This SB revises SB-912-068/SB-914-049 Initial Issue dated 16 April 2015

SERVICE BULLETIN

Specification/change of engine configuration and/or type plate for ROTAX_® Engine Type 912 and 914 (Series)

Fig. 1

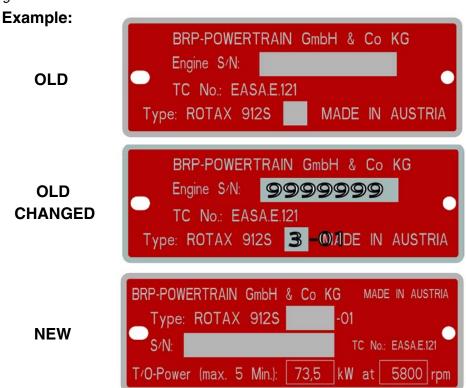
Suffix	Description	Note
-01	New cylinder heads have been introduced for the ROTAX 912/914 engine Series in order to standardize the cylinder head raw part with the ROTAX 912 iSc Sport engine series. As a result the measurement position of the temperature sensor on the cylinder head has changed as well as the measurement medium (former aluminium, now coolant).	912 S: 4 924 911 914 F: 4 421 445
	As a consequence for all ROTAX 912/914 engines, the type designations of which are extended with suffix "-01", the engine temperature measurement methods have been amended from CHT (cylinder head temperature) and CT (coolant temperature) to only CT (coolant temperature). Therefore only the coolant temperature limit applies.	which has been extended by some more information (see Fig. 1).
	Example for identification: "ROTAX 912 S3-01"

Step	Procedure	
1	Apply suffix	- 01 permanently (e.g. engraved, stamped or similar) to the type plate.
	NOTE:	Any changes regarding to this Service Bulletin must be confirmed in the engine logbook.
